SUBJECT: Manual Landing Gear Aircraft - Gear Handle Down-Lock Latch and Placard

AFFECTED: Part I and Part II - M20, M20A, M20B & M20C, - S/N's 1002 THRU 2050  
Part II - All Manual Gear Aircraft.

Service Bulletin M20-88B  
Date: 5-10-94

FIGURE SB M20-88A-1

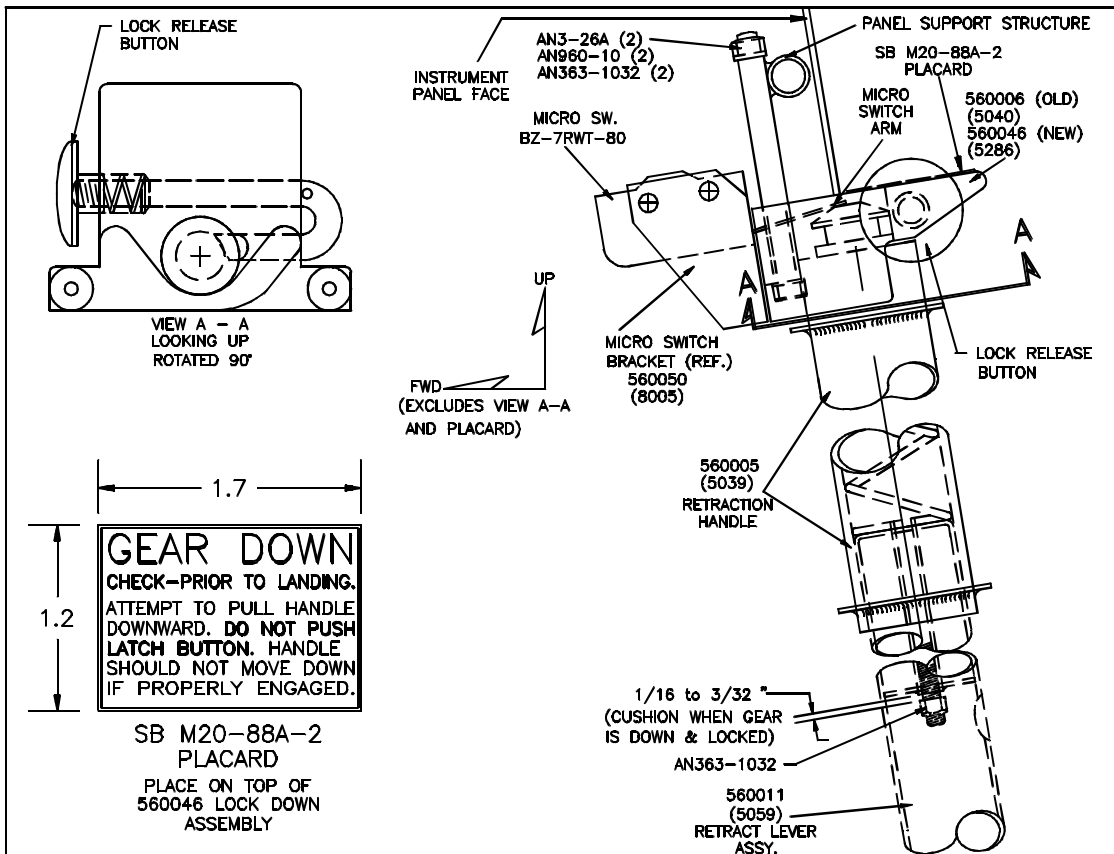
Place airplane on jacks before beginning down lock change. See Service and Maintenance Manual for proper method of placing airplane on jacks. Retract landing gear to keep handle out of the way. Remove two AN3-26A bolts which hold P/N 5040 (560006) to instrument panel support structure. Remove micro-switch and supporting brackets from P/N 5040 (560006) and re-install micro-switch and brackets to new handle lock assembly, P/N 5286 (560046). Attach P/N 5286 (560046) to instrument panel support structure with (2 each) AN3-26A bolts, AN960-10 washers and AN363-1032 nuts. Release gear from retracted position; remove and replace existing handle with P/N 5039 (560005) from this kit. P/N 5039 (560005) has machined groove in top fitting for positive latch pin to engage.

Adjust retraction handle length with AN363-1032 nut on threaded rod, so grip will bottom out into the 5286 (560046) lock assembly with from 1/16" to 3/32" excess length. If handle is too long, it may be difficult to extend landing gear because handle may have excessive friction upon entering latch casting portion of 5286 (560046) assembly.

Adjust micro-switch to close circuit for gear warning light (GREEN - Down and Locked) when handle is 1/8" or less from the maximum top position of handle latch mechanism. Bend micro-switch actuator arm if necessary for proper adjustment.

Place new placard, SB M20-88A-2, on top of 560046 retraction handle lock down assembly. Remove 150039-43 placard, if installed, prior to installation of SB M20-88A-2 placard.
